DSCA NO. **LA990009-1904**MODEL **FTF Compressor**DATE **05/12/06**PAGE **1 of 1**

TITLE: Compressor Assembly with Extra Components

Subject: Noise in Engine Compartment with Air Conditioning (A/C) On, A/C System Inoperative (Install Redesigned Rear A/C Suction Hose, Replace Compressor) #01-01-39-002B - (12/03/2001)

**Models: 2000-2001 Chevrolet and GMC C/K Utility Models
Built Prior to October 10, 2000
With Auxiliary Rear A/C (RPO C69)**

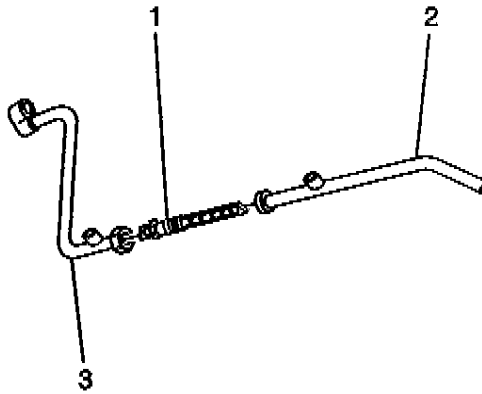
- Add 60 ml (2 oz.) of PAG oil, P/N 12345923 (in Canada, use P/N 10953486), plus the equal amount of oil drained from the accumulator.
 - Do not install the old suction hoses from the compressor and the rear A/C line to the new accumulator (3).
5. Replace the accumulator (3) with P/N 1132781. Refer to the Accumulator Replacement procedure in the Service Manual (SI 2000 Document ID #542037).

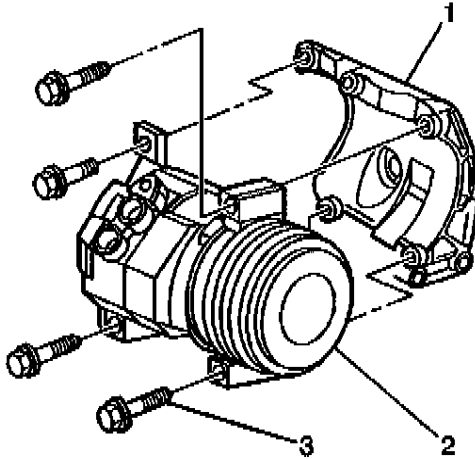
6. Replace the expansion (orifice) tube (1) with P/N 03096068. Refer to the Expansion (Orifice) Tube Replacement procedure in the Service Manual (SI 2000 Document ID #536021).

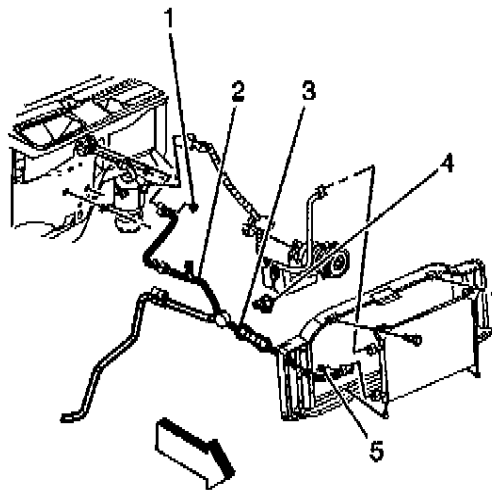
- Drain and measure as much of the oil as possible from the removed compressor.
 - Drain the oil from both the suction and discharge ports of the removed A/C compressor into a clean container.

- Measure and record the amount of oil drained from the removed A/C compressor. This measurement will be used during installation of the replacement A/C compressor.

- If more than 60 ml (2 oz.) of PAG oil was drained from the compressor, add the equal amount of PAG oil that was drained from the old compressor.
 - If less than 60 ml (2 oz.) of PAG oil was drained from the compressor, add 60 ml (2 oz.) of PAG oil to the new compressor.

7. Replace the A/C compressor (2) with P/N 15081861. Refer to the Compressor Replacement LR4, LM7, LQ4, L18 w/Denso procedure in the Service Manual (SI 2000 Document ID #448700).

8. Install the new suction hose, P/N 15065473, to the compressor (2) and to the accumulator. Refer to the Suction Hose Replacement LR4, LM7, LQ4, L18 w/Denso procedure in the Service Manual (SI 2000 Document ID #628200).

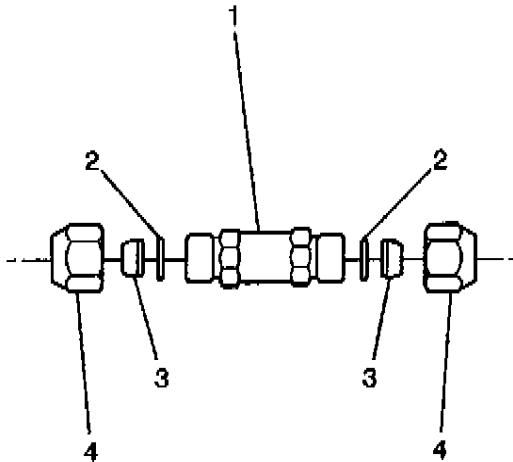
- Do not allow metal burrs to enter the evaporator tube (2) during cutting or when removing the burrs.
- When you section the A/C lines, ensure that the correct minimum length remains in the straight part of the line on both sides of the filter.

11. Using a tubing cutter, cut the marked section of the evaporator tube (2).
12. Remove the burrs from the evaporator tube (2).

13. Remove the nuts (4), the ferrules (3), and the O-rings (2) from the A/C refrigerant filter (1).

Important: Do not install the O-rings (2) in this step.

14. Push the nuts (4) and ferrules (3) over each of the evaporator tube halves.
15. Install the ferrules (3) with the small end toward the nut (4).
16. Install the A/C refrigerant filter (3), P/N 52474433, to the evaporator tube (2) with the flow arrow pointing towards the evaporator.
17. While holding the evaporator tube in the A/C refrigerant filter (1), tighten the nuts (4) to the A/C refrigerant filter (1).

18. Remove the nuts (4) from the A/C refrigerant filter (1).
19. Coat the O-rings (2) with 525 viscosity Mineral oil, P/N 5416939 (in Canada, use P/N 10953496).
20. Install the O-rings (2) to the evaporator tube halves.
21. Install the nuts (4) to the A/C refrigerant filter (1).

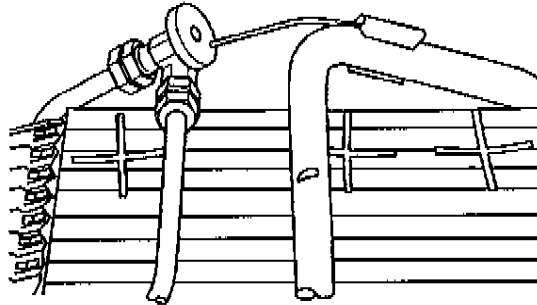
- Measure 152 mm (6 in) rear of first rear A/C line retaining clip and mark the suction line.
 - Do not allow metal burrs to enter the rear A/C suction line.
 - When you section the A/C lines, ensure that the correct minimum length remains in the straight section of the line on both sides of the splice.
24. Using a tubing cutter, cut the marked section of the rear A/C suction line and discard the front section of the line.
 25. Splice in the new front section of rear A/C suction hose, P/N 15095996, using J 41425 A/C Line Repair Kit and splice J 41425-750. Refer to the Heater and A/C Pipe Repair - Auxiliary procedure in the Service Manual (SI 2000 Document ID #594055).
 26. Connect the rear A/C suction line to the Y in the suction line attached to the compressor.
